UNITED STATES PATENT AND TRADEMARK OFFICE

Office Action Summary

09/609,868

WALKER, KENNETH GORDON

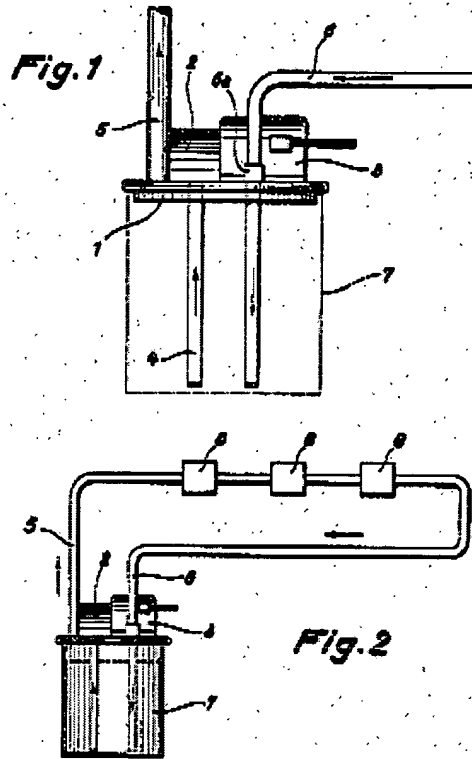
Claims 29, 31 and 36 are rejected under 35 U.S.C. § 102(b) as being anticipated by *Hesselmann* (3,382,886).

Regarding claim 29, *Hesselmann* teaches a lid (1) for a canister body (7), said lid (1) and canister body (7) together forming a canister for receiving liquids, said canister body (7) having side walls and a bottom, said lid comprising:

an inlet port (6a) in said lid for inflow of fluids into said canister (7);

an outlet port in said lid for outflow of fluids from said canister (7); and

a conduit (4) in fluid communication with said outlet port, said conduit (4) extending to the bottom of said canister body (7) when said lid (1) is placed in covering relation to said canister body (7)(see Figs. 1 and 2, below).

Regarding claim 31, *Hesselmann* teaches a vacuum port (2)(5) in said lid (1) for application of vacuum to said canister (7) for inducing flow of fluids into said canister (7).

Regarding claim 36, *Hesselmann* teaches a suction canister (7), comprising:
a chamber for receiving fluids, said chamber being partially defined by a bottom wall;
an inlet (6a) communicating with said chamber for the inflow of said fluids into said chamber;

a vacuum port (2)(5) communicating with said chamber for application of vacuum to said chamber;

an outlet communicating with said chamber for outflow of said fluids from said chamber;
and

a conduit (4) in fluid communication with said outlet and extending to said bottom wall of said chamber (*see* Figs. 1 and 2, above).
